ORIGINAL APPLICATION NO.104 OF 2020

**REPORT OF THE JOINT COMMITTEE FILED BY CENTRAL POLLUTION CONTROL BOARD (CPCB) WITH REGARD TO HON'BLE TRIBUNAL ORDER DATED July 01<sup>st</sup>, 2021**

**REPORT OF JOINT COMMITTEE ON THE OBJECTIONS FILED BY THE RESPONDENT -8 IN THE MATTER OF O.A. 104 OF 2020 (SZ), IA 75 OF 2021 (SZ) AND IA 79 OF 2021 (SZ) SUBMITTED BEFORE THE HON'BLE NATIONAL GREEN TRIBUNAL, SOUTHERN ZONE, CHENNAI**

Figure 1. Location of Ganaludoddi village and Girenahalli village

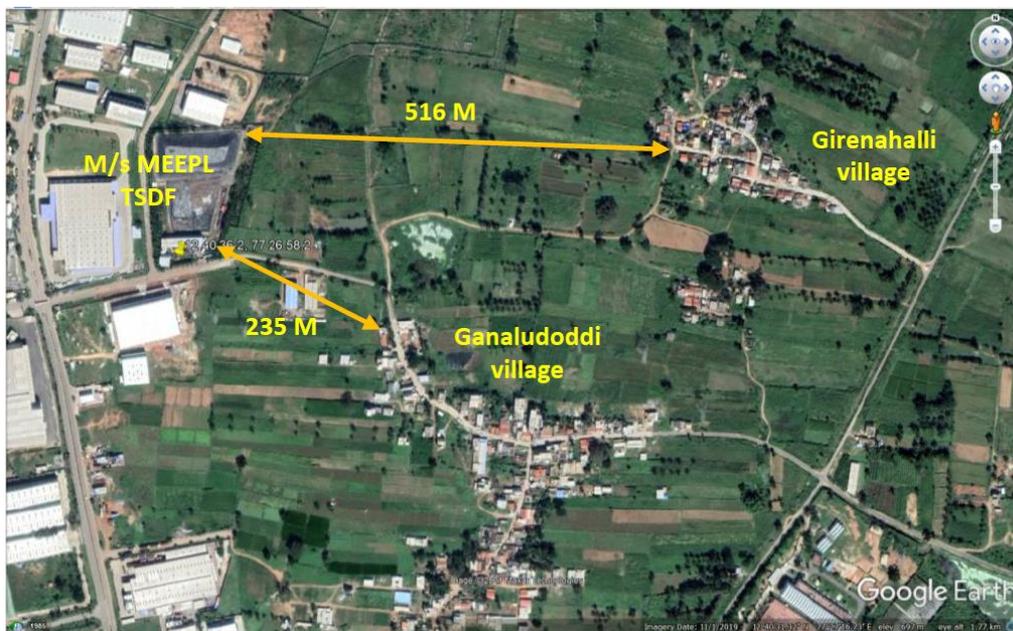
- i. As per the "Criteria for Hazardous Waste Landfills" published by CPCB in 2001, landfill shall be at least 500 M from a notified habitation area. A zone of 500 M around a landfill boundary should be declared a no-development buffer zone after landfill location is finalized (Annexure 2).
- ii. There are two villages located near the vicinity of M/s MEEPL. Ganaludoddi village and Honnur Swamy Temple of the village are located about 200 M and Girenahalli village is located at more than 500 M distance from the TSDF. The google images

of locations of the villages are shown in Figure 1. 500 M around the landfill boundary has not been declared as non-development buffer zone till date. Thus, the TSDF is not complying with the siting criteria.

Figure 2: Location of seven lakes around the TSDF

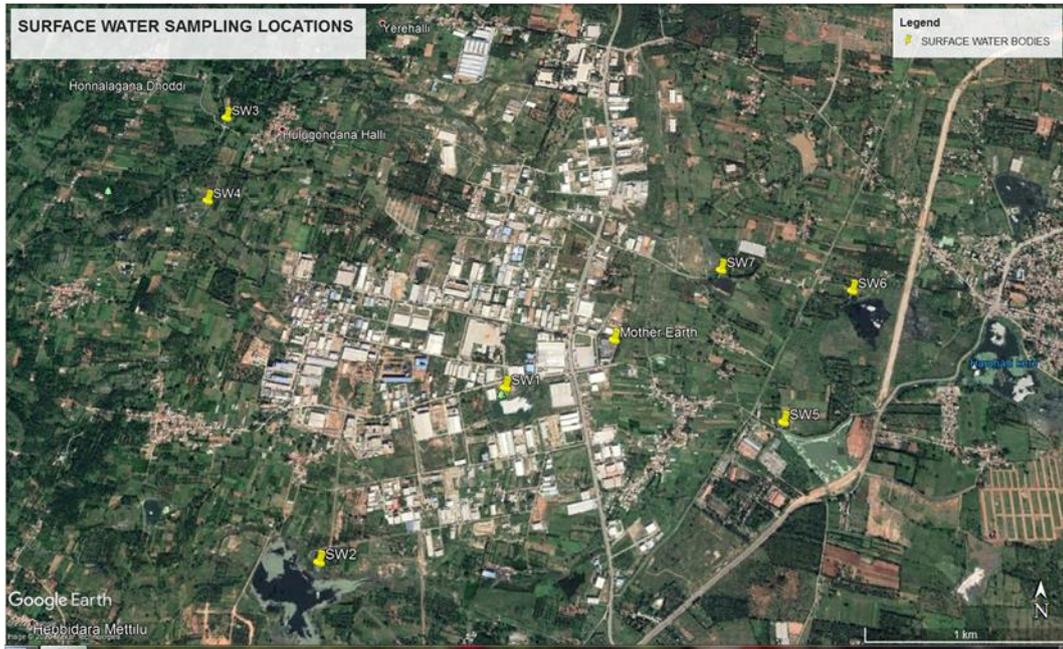
- i. During the joint committee inspection on 03/09/2020, water quality analysis of following seven lakes located in the surrounding of TSDf were carried out:
  - a. Hanumegowdanu Doddi Lake - SW1
  - b. Bani Kuppe Lake - SW2
  - c. River Sornamukki - SW3
  - d. Malliahnakere - SW4
  - e. Ganaludoddi near BWSSB - SW5
  - f. Hodakekere, Kulume Beemasandara Village - SW6
  - g. Soothakatte, Girenahalli Lake sample - SW7
- ii. Analysis results of the surface water samples collected from seven lakes shows that the concentrations of total dissolved solids were higher in Hodakekere lake (SW6) and Soothakatte lake (SW7) located in downstream of the TSDf compared to other lakes.
- iii. The location of the TSDf and seven lakes in google image are shown in Figure 2 and toposheet indicating location of TSDf provided by Respondent - 8 is in Figure 3.

Figure 3: Topo sheet showing location of seven lakes and TSDF

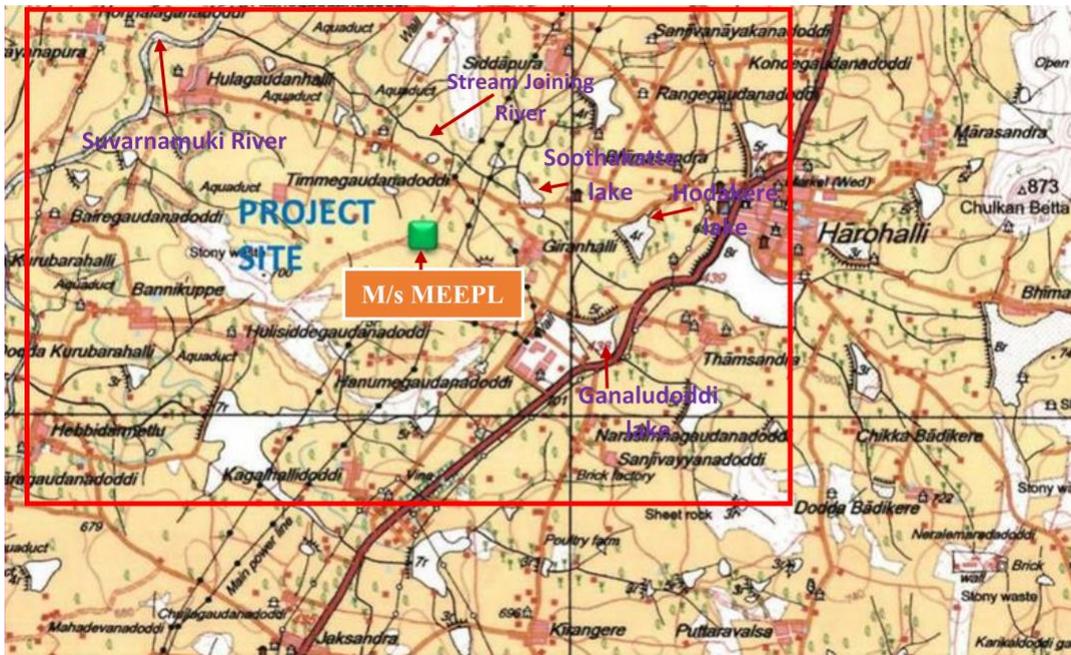
- iv. The Respondent -8 mentioned that the TSDF is in catchment of Ganaludoddi lake (SW5) and the gradient is towards east and flow cannot be towards two lakes Hodakekere lake (SW6) and Soothakatte Lake (SW7) and the TSDF is not in the catchment of Hodakekere lake - SW6 and Soothakatte Lake (SW7).

- v. The contours and interconnected chain of lakes in the toposheet at Figure 3 shows that Ganaludoddi lake, Hodakekere lake and Soothakatte Lake are in the catchment of Suvarnamuki River. Soothakatte Lake (SW7) is located in north-east of TSDf and Ganaludoddi lake (SW5) is located in south west. The contours and drainage network in the toposheet shows that runoff flow from TSDf is towards north and north- east. The contours and drainage network indicates that Soothakatte Lake (SW7) is in the downstream of Ganaludoddi lake ( SW5) and further overflow from these lakes joins Suvarnamuki river flowing in the north –west of the TSDf.

Drawing Title  
**Plant Layout**

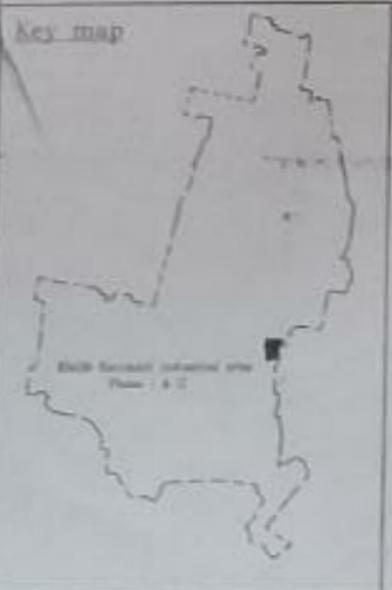
- ii. The Joint Committee reviewed the approval of the layout plan and noticed that the M/s MEEPL has submitted a layout plan dated 26/09/2018 to KSPCB including the buffer area of 15 M x 175.5 M (2632.5 M<sup>2</sup>) belonging to KIADB, accordingly KSPCB has approved layout plan including KIADB land. KIADB official clarified to the Joint Committee on 03/09/2020 that permission was given to MEEPL only to maintain the additional buffer area adjacent to MEEPL site on their East side i.e. 15 M x 175.5 M , but, they can't claim any ownership or as their greenbelt and can't include in their layout plan. Also, observed that there is no plantation / greenbelt developed in the additional buffer area till date neither by KIADB nor by MEEPL.

- iv. CPCB has examined the reply of KSPCB dated 14/11/2018 and informed that layout plan approval by KSPCB does not meet the required green belt as prescribed in the EC and also not having required infrastructure as per CPCB Guidelines. CPCB requested KSPCB to revisit the design and layout approved by them and may seek expertise of reputed institute while considering the approvals including of sizes / capacities of various infrastructures and requested for immediate compliances of the directions.
